ADDENDUM 001
REQUEST FOR BIDS
“SURVEYOR AND SUPERVISOR VESTS”

IFB 1-060706

ISSUE DATE: June 23, 2006

Figure C-5. Vest Pattern 2 (Performance Class 2)

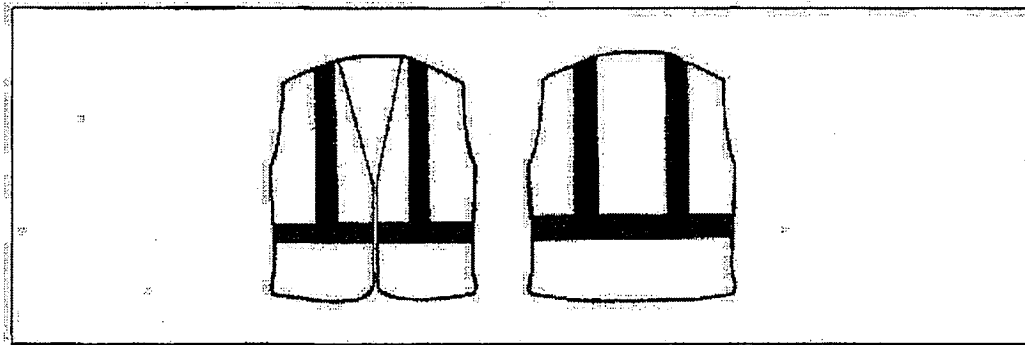
1. Where is the exact placement of the 8935 Fire Retardant (FR) trim?

See the below Figure C-5 for placement of trim
